**BLOOMINGTON PLAN COMMISSION
STAFF REPORT
Location: 105 & 111 W. 4th Street**

**CASE #: SP-04-20
DATE: March 9, 2020**

REQUEST: The petitioner is requesting site plan approval for a new parking garage in the Commercial Downtown zoning district.

Subject: SP-23-19: City of Bloomington, Fourth Street Parking Garage
105 & 111 West 4th St., and 222 South Walnut St.

DRAWING TITLE:
PRELIMINARY SITE PLAN

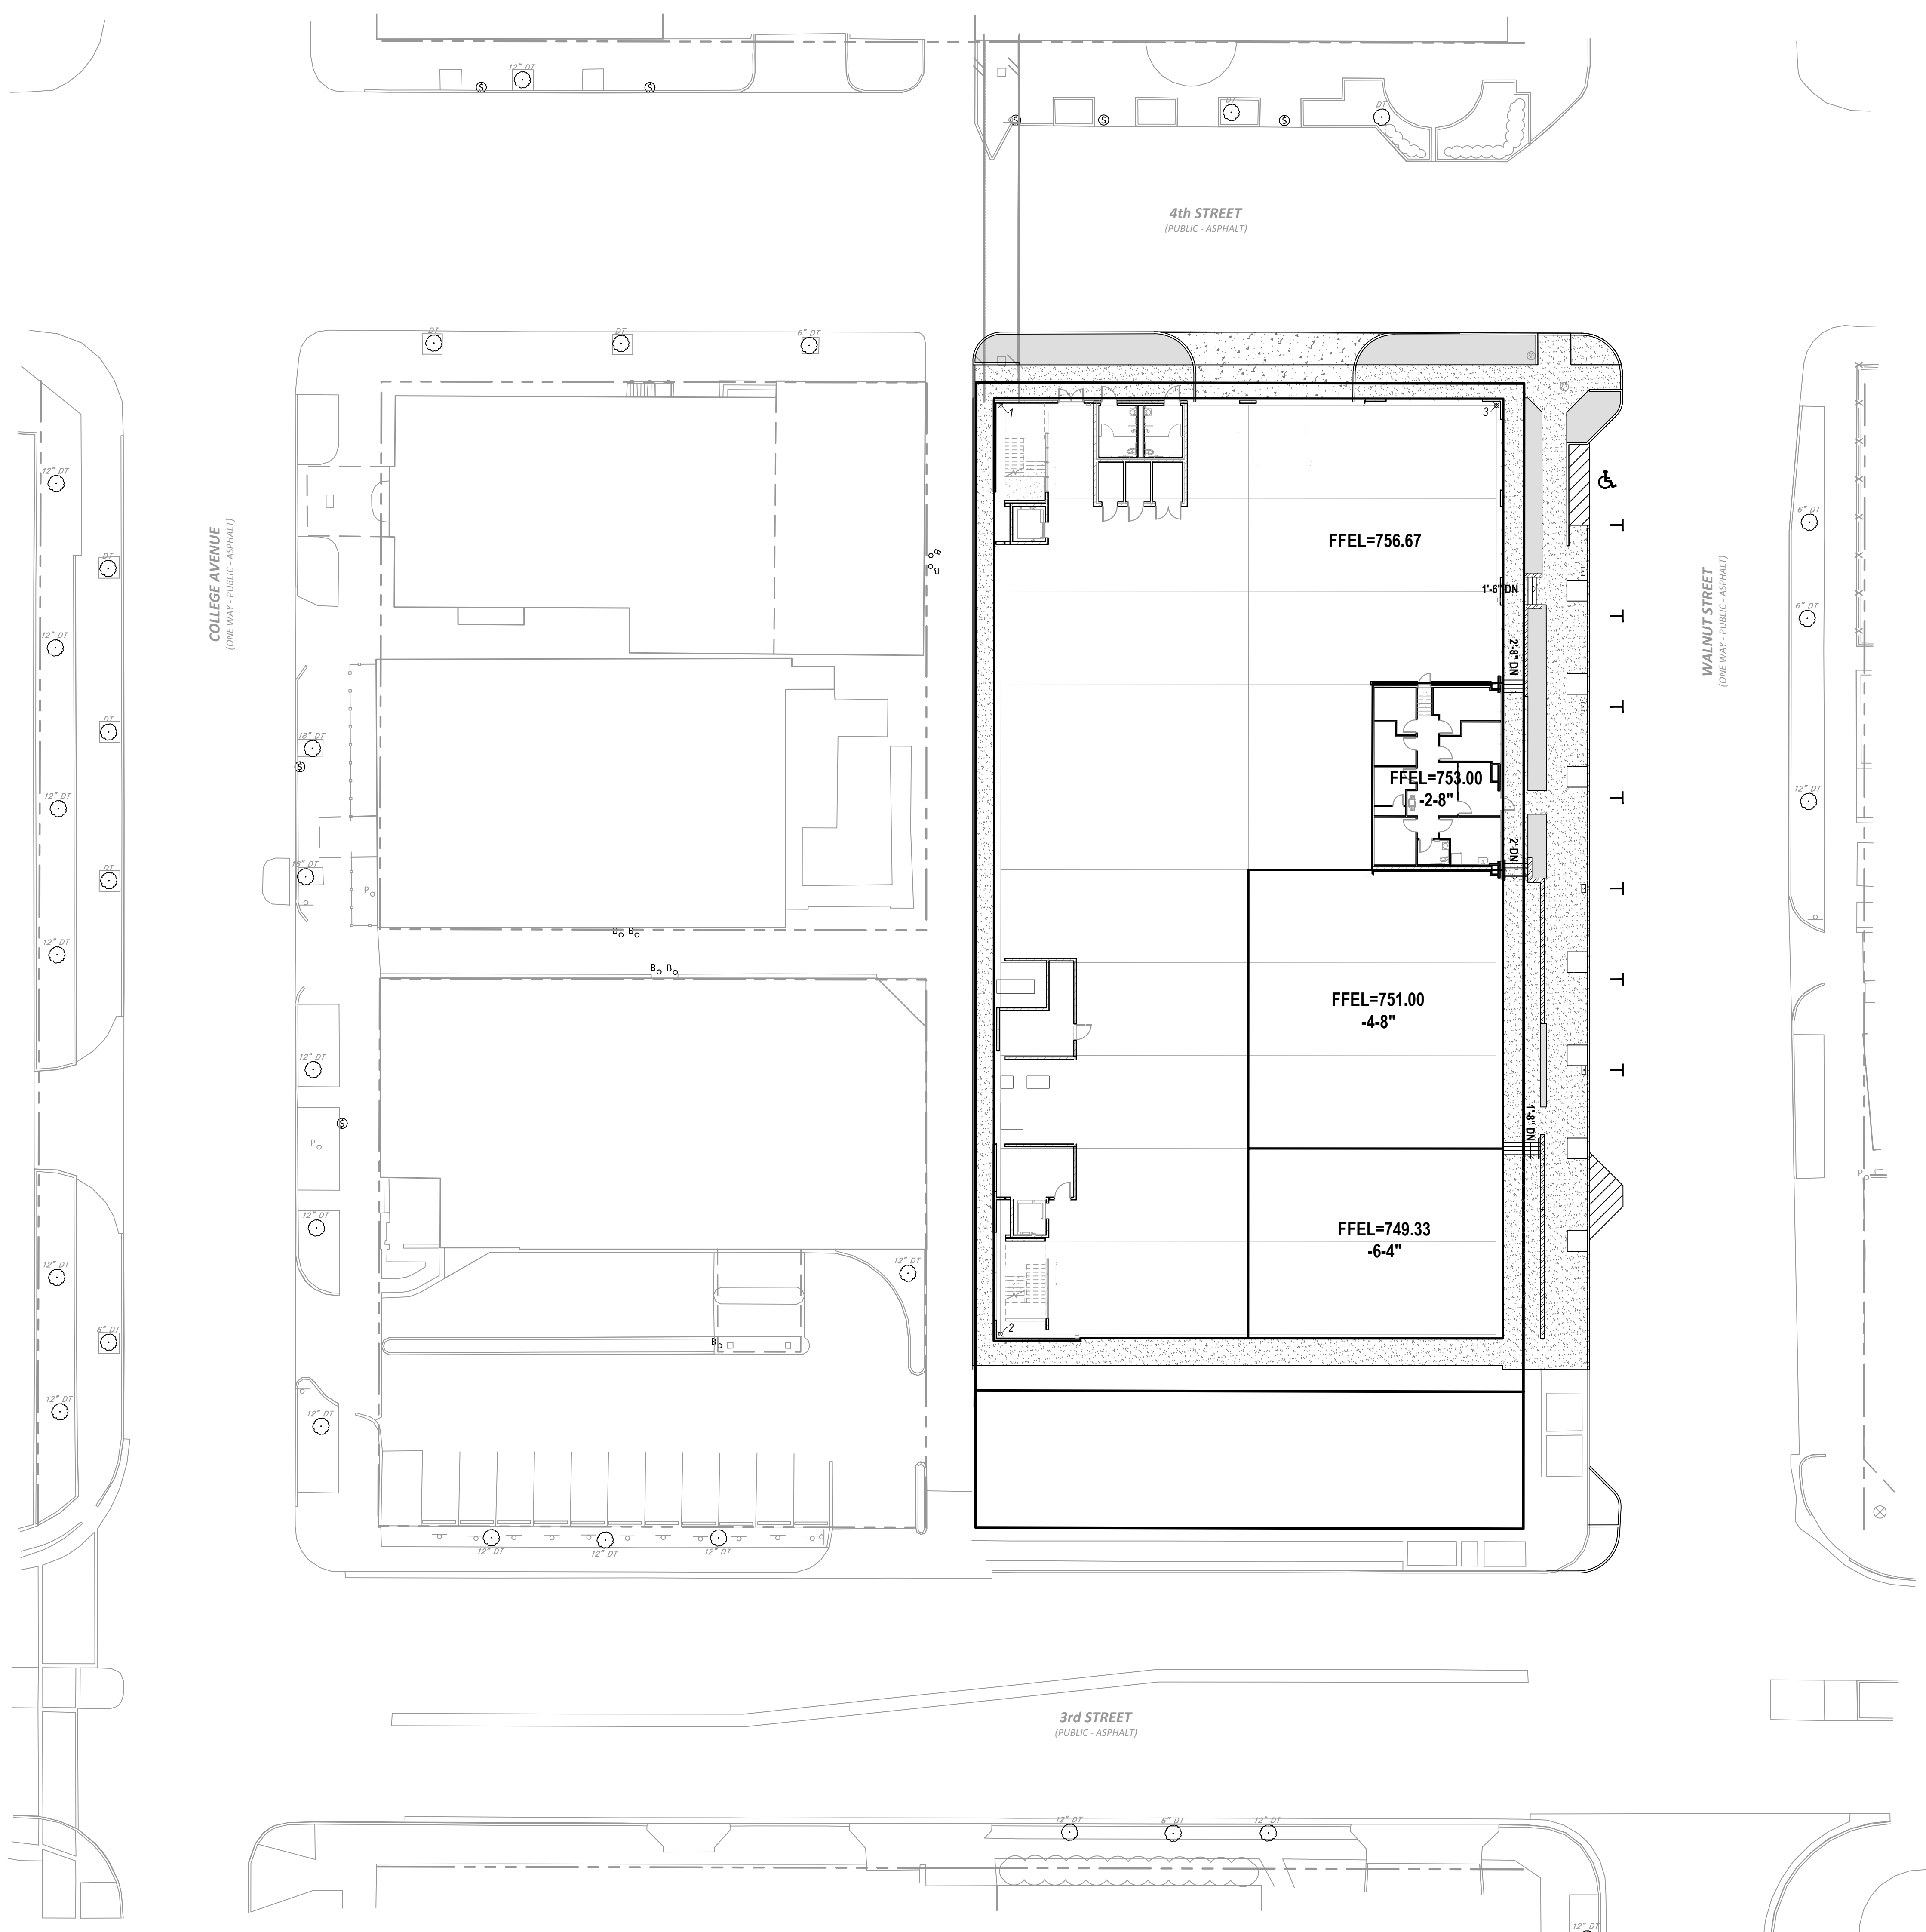
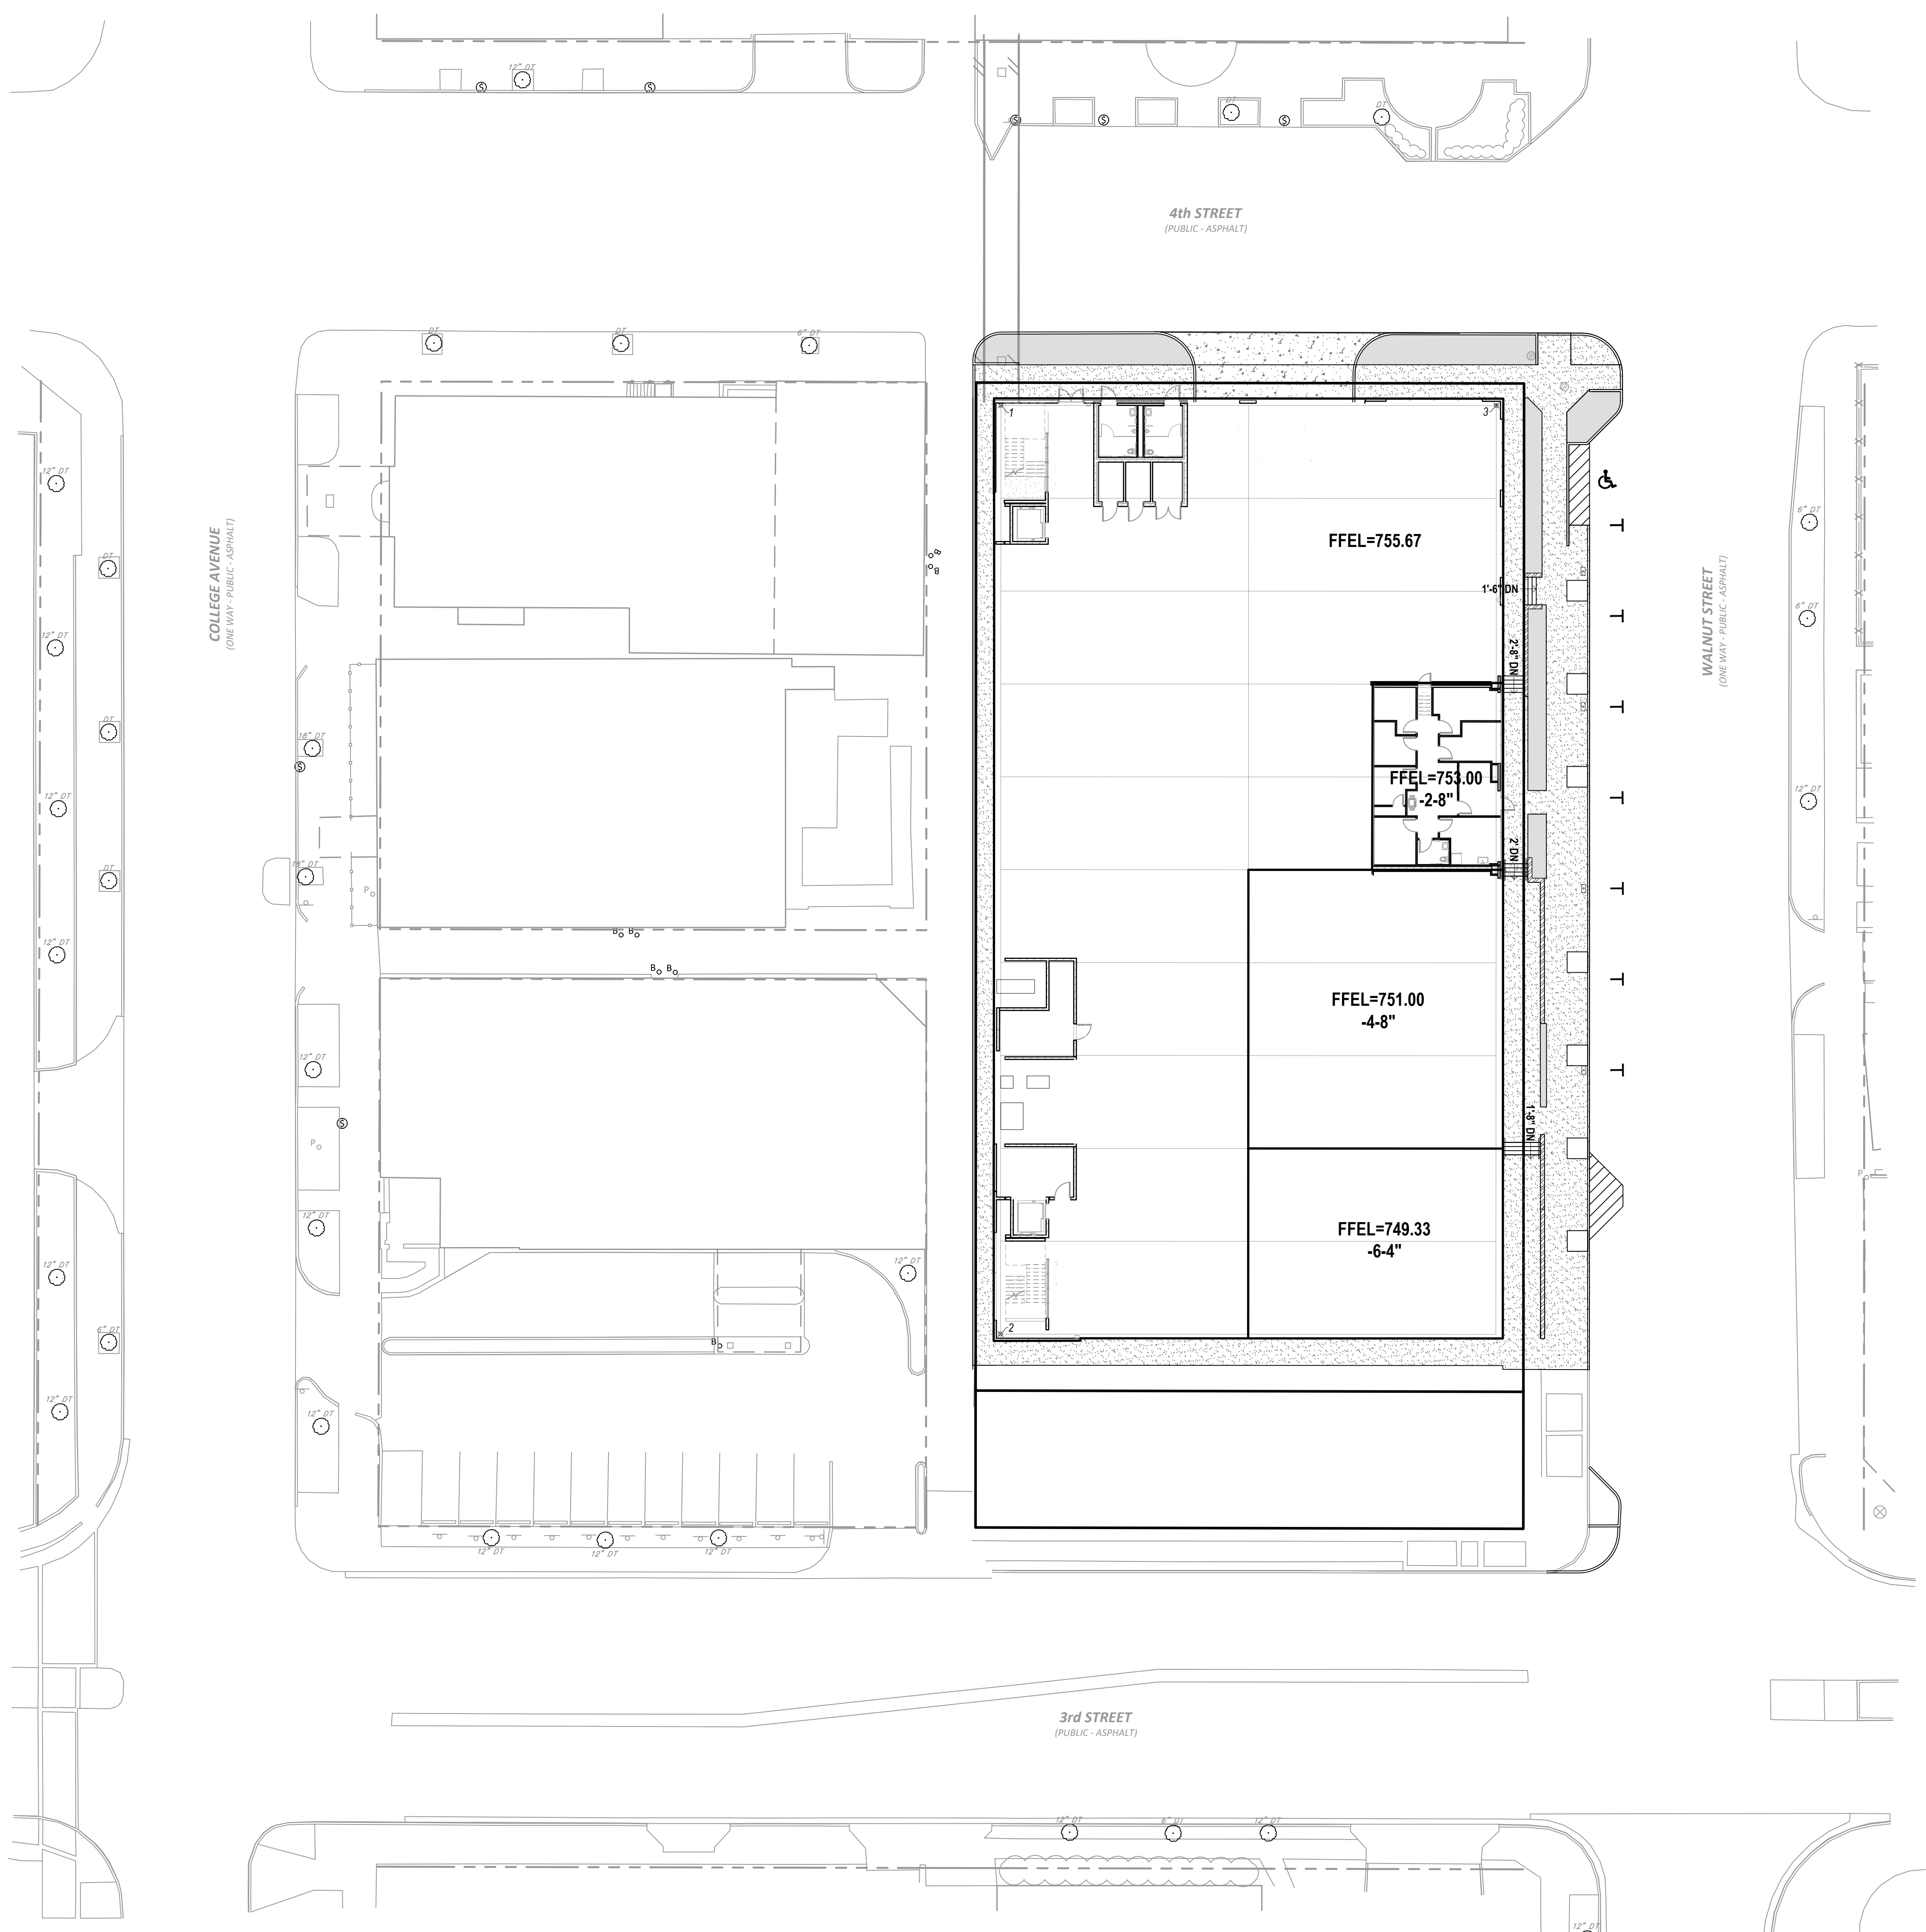
Build-to-Line: The UDO requires buildings in the Downtown Core Overlay to be built at the front property line. The 4th Street and Walnut Street facades are set back. The proposal does not meet this UDO requirement.

Access: There is one proposed vehicular access to the parking garage on 4th Street. The entrance is for three total lanes. One dedicated entrance lane, one dedicated exit lane, and one lane to alternate as an entrance/exit as needed. The UDO allows for a maximum driveway width of 24 feet on 4th Street, and a maximum driveway width of 34 feet on any of the highest classified roads in the City. The petitioner is requesting a 39 foot entrance, which is comparable to the

entrance on the former garage at this location. The entrance width will require variance approval by the Board of Zoning Appeals. Additionally, a 100 foot separation from Walnut Street is required, and the petitioner is showing about 65 feet of separation. The entrance location will also require variance approval by the Board of Zoning Appeals.

Pedestrian access to the garage is shown in the southwest and northwest corners of the building, near the stair towers and pay locations. 20.03.130(b)(6) requires recessed entry for pedestrian entrances on primary facades to help identify and demarcate these locations. The petitioner is requesting deviation from that standard for the entrance at the northwest corner of the garage.

The Department has concerns about visibility of pedestrians on 4th Street from vehicles exiting the garage. The current design is open at the northeast corner, which may allow for more visibility, but a more interesting treatment of that interface, artistic bollards for example, would delineate the entrance as bicycle and pedestrian only. A condition of approval has been added to include that additional entrance. The Department asks that the petitioner continue to work on the pedestrian entrances to make them more visible and to improve pedestrian visibility in those areas. Additionally, the Department would like the entrances for the commercial space(s) to meet the intent of the remainder of that reference, 20.03.130(b)(6)(B) & (C), by incorporating distinctive awnings, canopies, or something similar identifying those entrances.

1. The approval is contingent upon approval of the variances by the Board of Zoning Appeals related to entrances and drives, as listed in this report.
2. The petitioner will continue to work with Planning and Transportation staff to improve the vehicular portion of the Walnut Street right-of-way by including bump-outs at the 4th Street corner.
3. Required bicycle parking for the commercial spaces will be added to the site plan before a grading permit is approved.
4. The petitioner will submit a site plan that meets the minimum street tree requirement. If the petitioner desires to use a portion of the tree plot area for bioretention to serve the site, the Senior Environmental Planner must review such a plan and approve any reduction in street trees.
5. The petitioner will submit a plan for pedestrian improvements to the alley east of the site,
